MEMORANDUM

SUBJECT: **Proposed Grove Development
Technical Analysis Report On Traffic Review Process**

RE: Withdrawal of July 21, 2016 TIA Addendum for The Grove at Shoal Creek PUD;
City of Austin File No. C814-2015-0074

CONCEPTUAL ROADWAY PLAN
 THE GROVE
 JACKSON STREET & 45th STREET

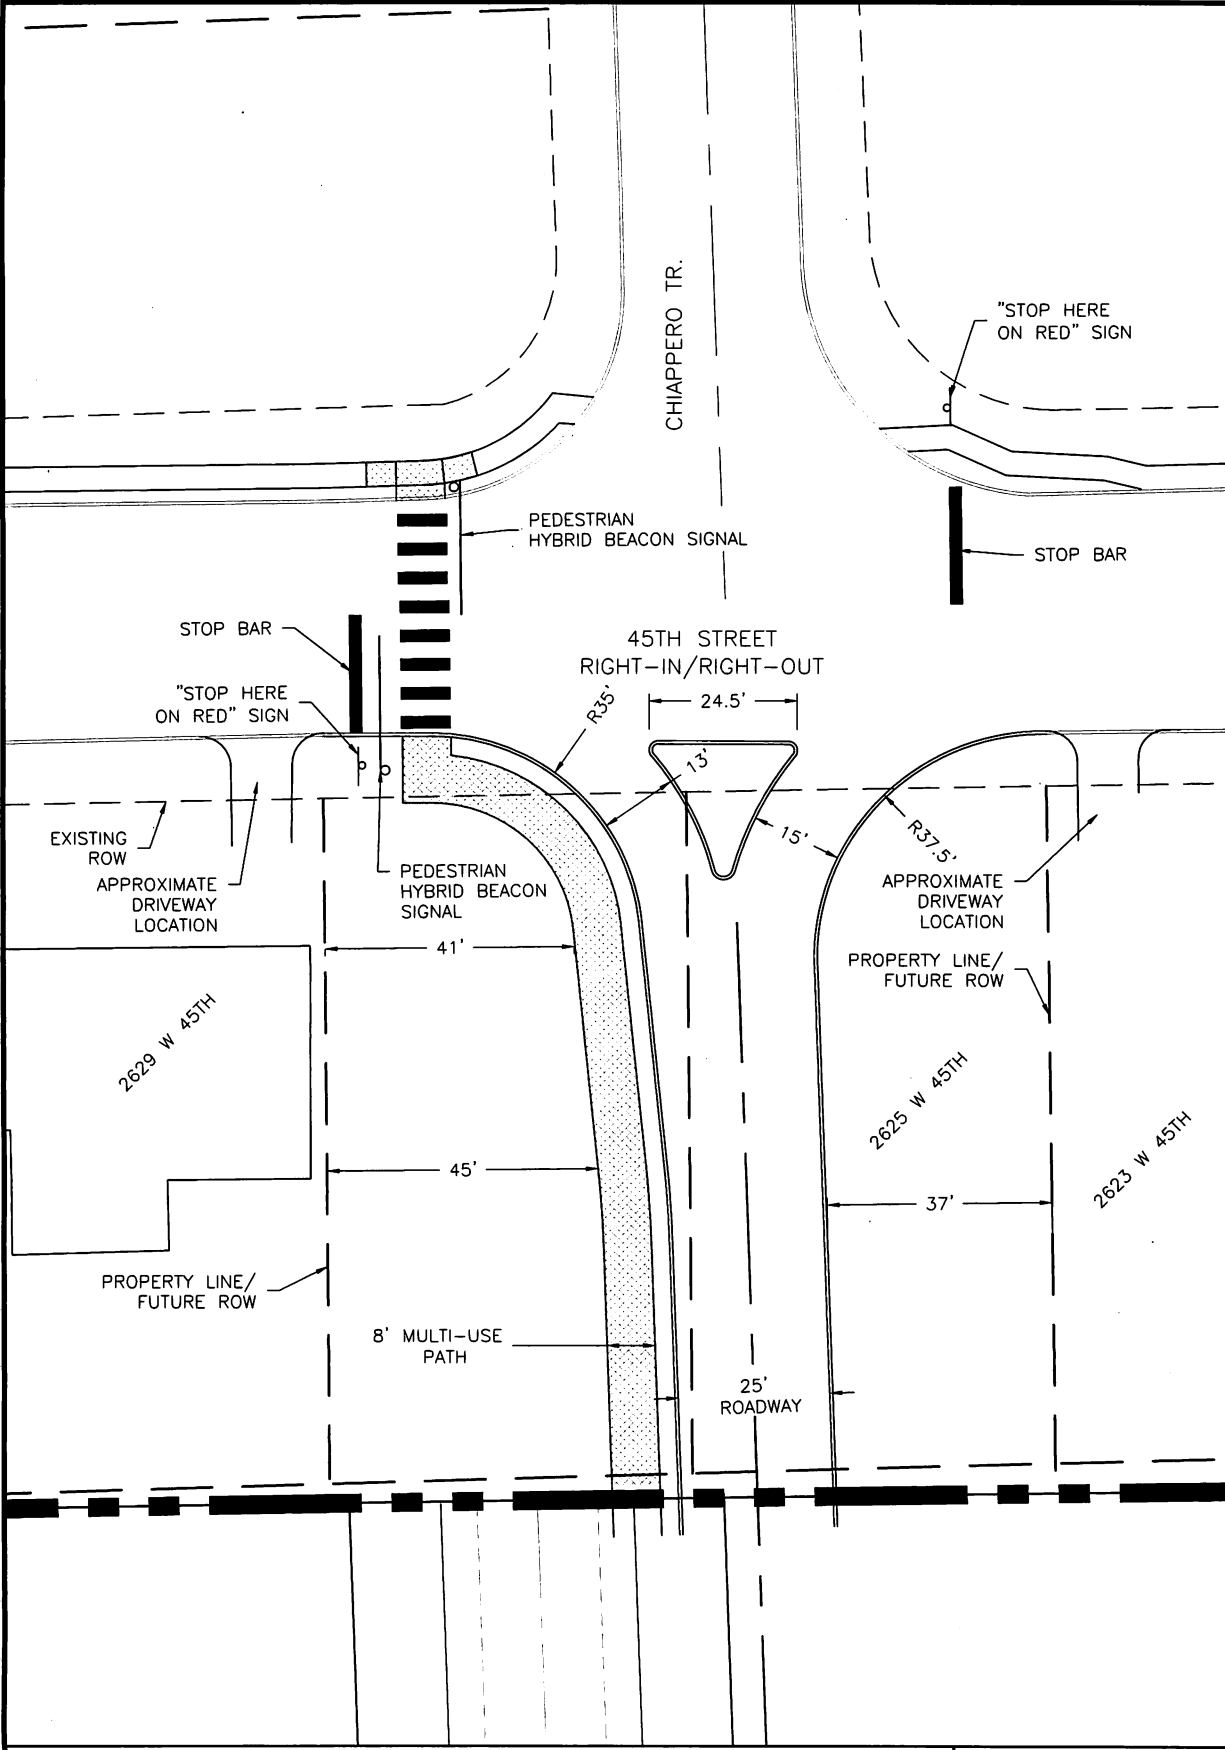
Notwithstanding the foregoing, and for clarification, the most recently proposed intersection of Jackson Avenue and 45th Street that is being considered by staff simultaneously with the Addendum remains the Applicant's proposed configuration of that intersection. That proposed intersection will be (i) right-in, right-out only, and (ii) aligned with Chiappero Street, as depicted in the attached conceptual design. The City's TIA Memo calls for this connection, and the enclosed conceptual design was provided to staff to answer any questions over how this connection might occur. Withdrawal of the Addendum does not mean that this connection or the proposed configuration is also being withdrawn. The Applicant understands that the enclosed conceptual design of this intersection has, subject to review and approval of final construction drawings, been accepted by the City staff as a generally and conceptually feasible approach to this intersection.
